National Committee on Uniform Traffic Control Devices (NCUTCD)

Recommended Changes to Proposed Text for 11th Edition of the MUTCD

Docket Number: FHWA-2020-0001

NPA MUTCD Section Number: Sections 6F.01 to 6F.03

Figure 6F-2. Methods of Mounting Signs Other Than on Posts

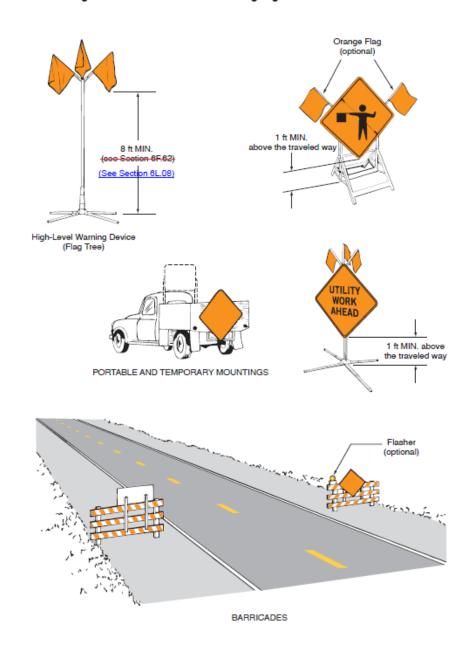
- **Figure 6F-2 Comments:** NCUTCD generally agrees with Figure 6F-2, but recommends the following:
- Revise callout to reference the correct section for the High-Level Warning Device (Flag Tree)
 - Update the graphics in the figure to depict contemporary implements such as the truck and sign supports
